KS-1 KITCHEN SINK

Shop Drawing Submittal Review

Project Name: Webster University-**ISB**

SPEC SECTION: 22 4216.16
Commercial Sinks

LK35, LK35B and LK35L Models

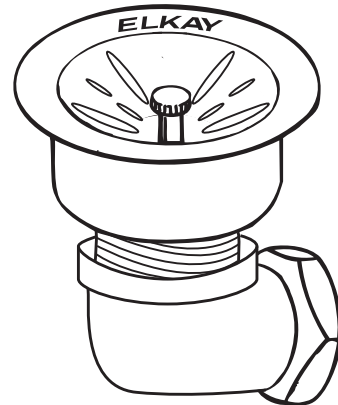
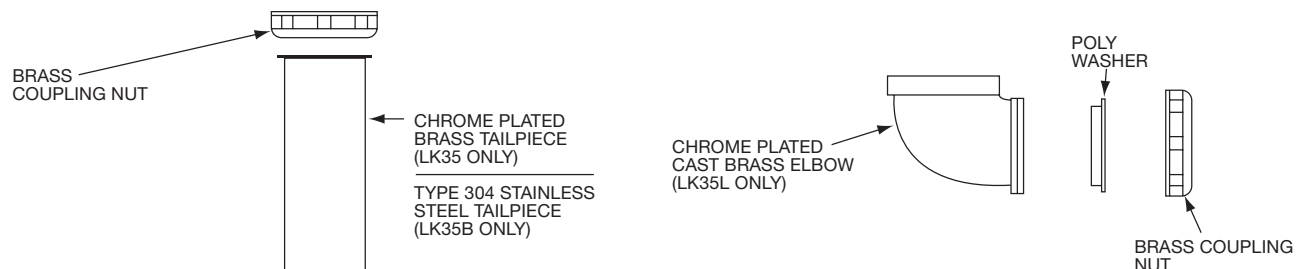
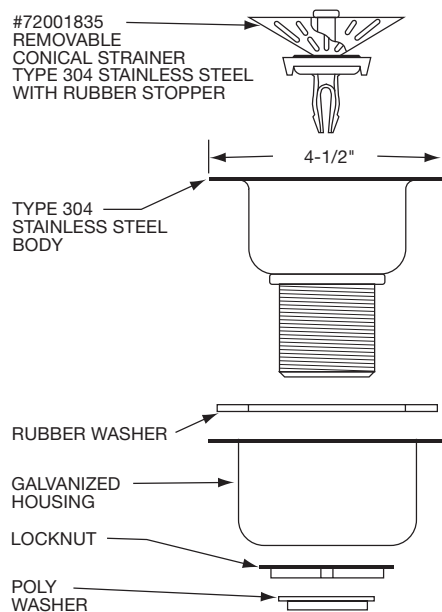
1. Cut sheet indicates a 3-hole punch - verify this with faucet 4-hole punch requirement.
2. Provide under counter waste and supply protective piping covers as required.
Verify requirements with the architectural drawings.
3. Escutcheons are specified to be cast brass. Refer to specification section 220518.
